ANN ARBOR HISTORIC DISTRICT COMMISSION

Staff Report

ADDRESS: 517-535 West William Street, Application Number HDC 13-127

APPLICATION: The applicant seeks HDC approval to install six square windows in new openings on the east second-floor wall of the former Argus Camera Company cafeteria.

EAST ELEVATION
ARGUS SECOND FLOOR

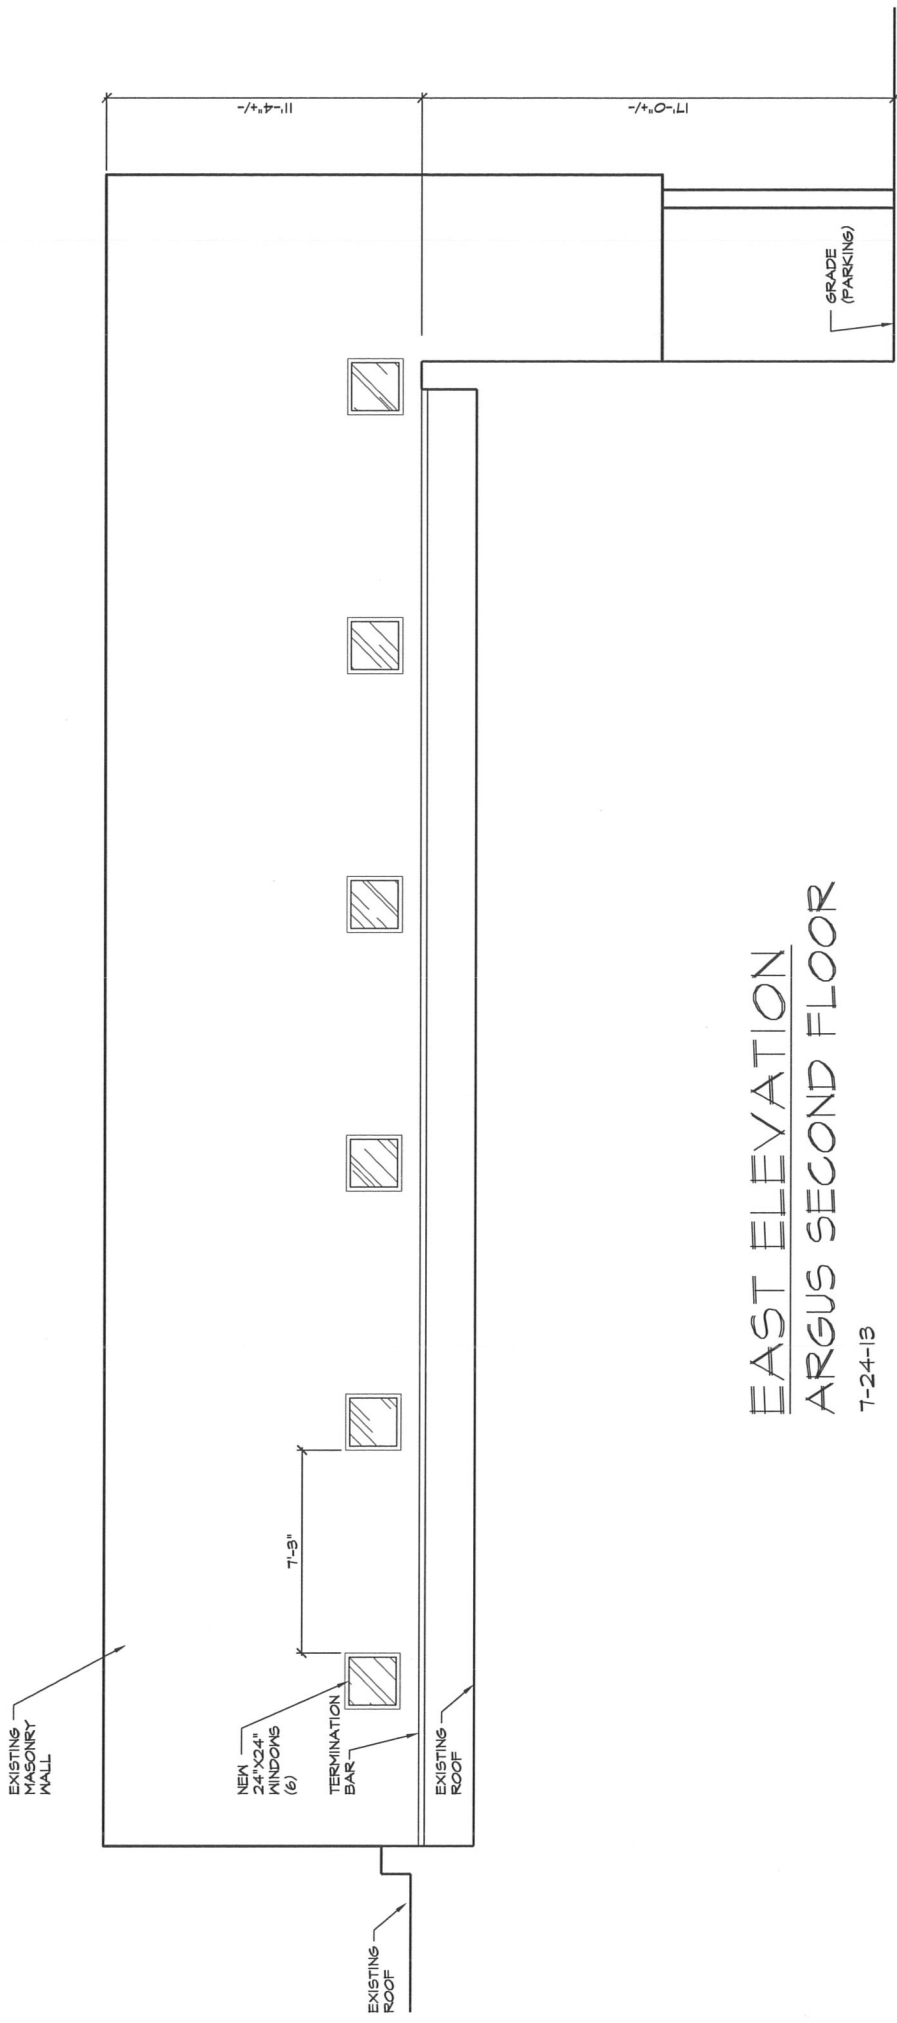
1. The applicant wishes to install six 24" square, aluminum, awning windows in a concrete block exterior wall. The windows would be equally spaced along the length of the wall, and only one (on the north end of the row) would be visible from the street or parking lot. The others are obscured from sight by the parapet of the one-story section of the building over which the windows look.
2. In keeping with the SOI *Guidelines for Windows*, this work would be located on a non-character-defining elevation and its design is compatible with other square non-original window openings on this portion of the building. The interior ceilings will be setback to allow natural light through the new windows.
3. Staff believes this work is compatible with the historic character of the property, differentiated from the older portions of the building, and conforms to the SOI Standards and Guidelines.

I move that the Commission issue a certificate of appropriateness for the portion of the application at 517-535 West William Street, a contributing property in the Old West Side Historic District, to install six new aluminum awning windows, as proposed. The work is compatible in exterior design, arrangement, texture, material and relationship to the rest of the building and the surrounding area and meets *The City of Ann Arbor Design Guidelines for Historic Districts*, and *The Secretary of the Interior's Standards for Rehabilitation and Guidelines for Rehabilitating Historic Buildings*, in particular standards 2 and 9, and the guidelines for windows.
